STAFF RECOMMENDATION
120 S. 11th Street (1021 Russell Street)
August 18, 2021

Application: New Construction—Infill; Partial Demolition
District: Lockeland Springs-East End Neighborhood Conservation Zoning Overlay
Council District: 06
Base Zoning: MUL-A
Map and Parcel Numbers: 08309022800 & 08309022700
Applicant: Tracey Ford, EOA Architects
Project Lead: Melissa Sajid, melissa.sajid@nashville.gov

Description of Project: Application is to reconstruct the tower that was damaged by the March 2020 tornado and to construct a new infill structure that is attached to the historic house.

Figure 5. 1021 Russell St, March 2016, Google maps. Figure 6. Proposed tower.

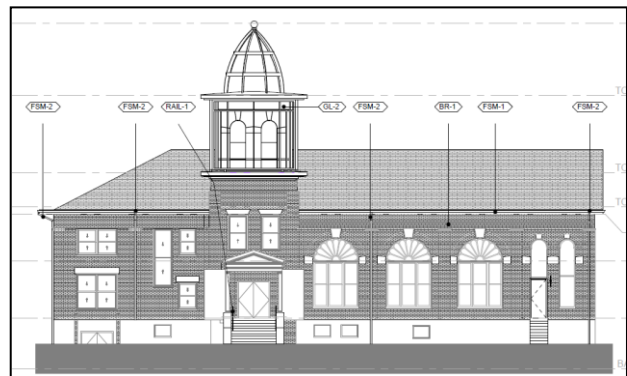
The preservation permit did not include the reconstruction of the tower, which is now proposed with this application. The applicant proposes to reconstruct the tower with the same dimensions as what was there originally, but the proposes to use metal and insulated frosted glass (Figures 5-6) as a contemporary version of what was lost.

While replacing historic materials does not meet the guidelines, the historic materials are no longer present due to circumstances beyond the owner’s control. Staff finds that

reconstructing the tower at the same scale but with contemporary materials can meet Section III.B.1 of the design guidelines since the tower is a character-defining feature.
